TING/POP/CLICK NOISE—FRONT HALFSHAFT	TSB 13-5-14
---	--------------------

FORD:
2011-2013 Taurus, Explorer, Flex

LINCOLN:
2011-2013 MKS, MKT

This article supersedes TSB 12-6-6 to update the Title, Issue Statement and vehicle model lines.

Figure 2 - Article 13-5-14

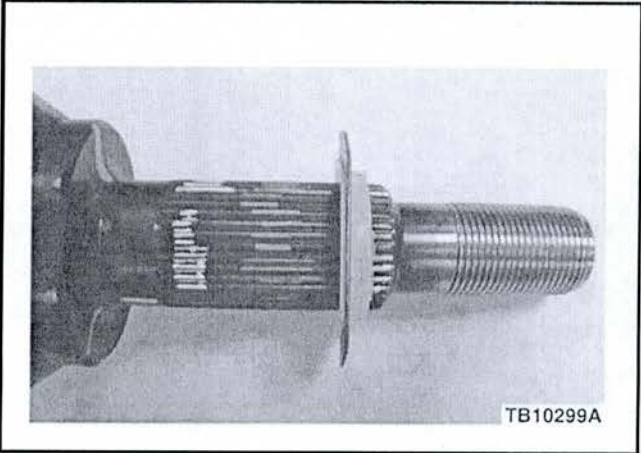
Some 2011-2013 Explorer, Flex, Taurus, MKT and MKS vehicles may exhibit a noise that could be described as ting, pop or click noise from the front wheel area when accelerating from a stop or when shifting between drive/reverse and/or reverse/drive.

1. Separate halfshaft from wheel hub. Refer to Workshop Manual (WSM), Section 205-04.
 - a. Do not remove halfshafts from transmission or power transfer unit (PTU).
2. Install one (1) thrust washer, metal surface first, over the halfshaft splines until the metal ring is flat against the wheel bearing mating surface. The nylon surface should face outward toward the hub/splines. (Figures 1 and 2)
